World Forum for Harmonization of Vehicle Regulations

Proposal for Supplement 1 to UN Regulations No. 168 (Global Real Driving Emissions (Global RDE))

Submitted by the Working Party on Pollution and Energy*

The first graphic in Annex 3, amend to read:

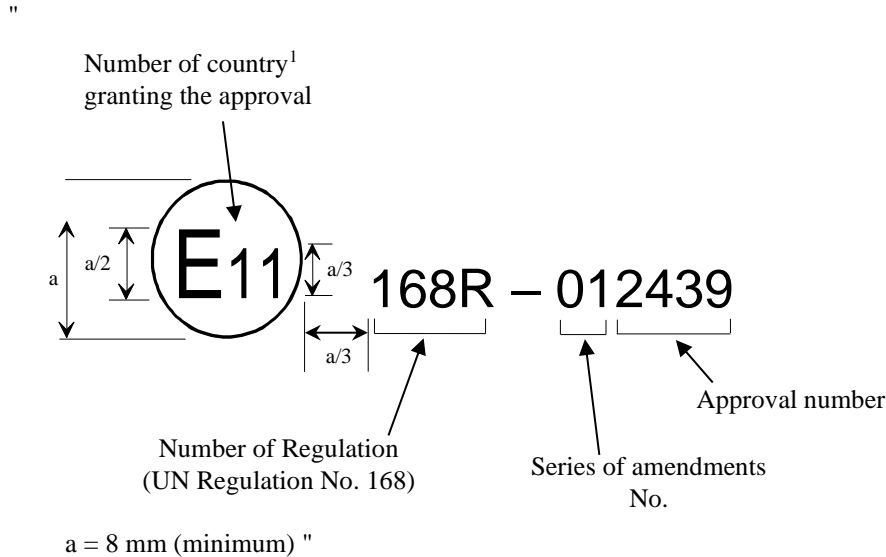
Annex 3, amend to read:

"This annex outlines the appearance of this mark and gives an example how it shall be composed.

The following schematic graphic presents the general lay-out, proportions and contents of the marking. The meaning of numbers and alphabetical character are identified, and sources to determine the corresponding alternatives for each approval case are also referred."
